VEHICLE RECALL

G-06505
September, 2006

SUBJECT:NON-COMPLIANCE RECALL (U.S., EXPORT)
**Davenport / Floor Joint on certain RE Buses built
between 07/01/2005 and 05/09/2006.**

Figure 2.

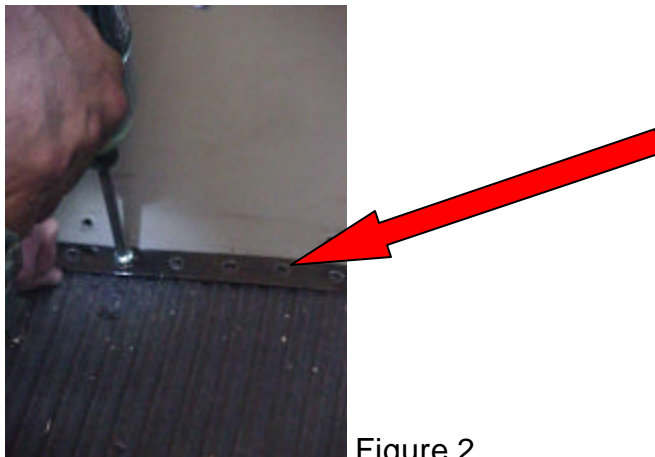
5. Before drilling any of the screw holes, place a magnetic strip or other drill guard along the vertical face of the davenport closeout to protect the painted surface from damage.
6. Using the pilot holes in the retaining bar as guides, drill through the floor material into the metal support bar under the floor with an 11/64" bit. It is recommended that a screw is installed in every 5th hole to prevent the bar from shifting or "pie crusting" (wavy affect) as the holes are drilled and screws installed.
7. Install a screw in each pilot hole location. See Figure 2.

Figure 4.

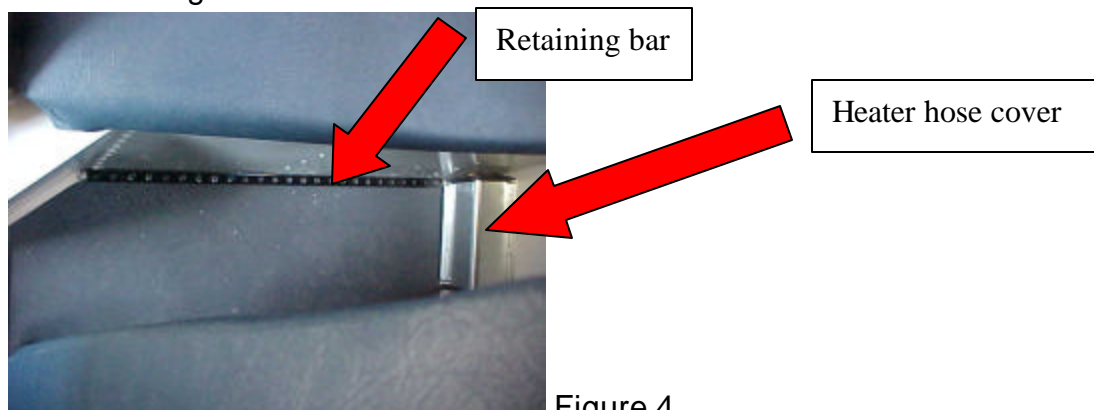
12. Drill and install screws in the pilot hole locations following the guidelines for the right hand side retaining bar.
13. Place the remaining retaining bar along the left hand side of the davenport closeout. The retaining bar on the left hand side must not be placed all the way to the side wall due to the heater hose cutout in the davenport cover. The outside end of the retaining bar must be lined up with the cutout in the davenport closeout for the heater hose. The end of the heater hose cover must be lifted to locate and mount the end of the bar. To lift heater hose cover remove screws as needed. See Figure 4.
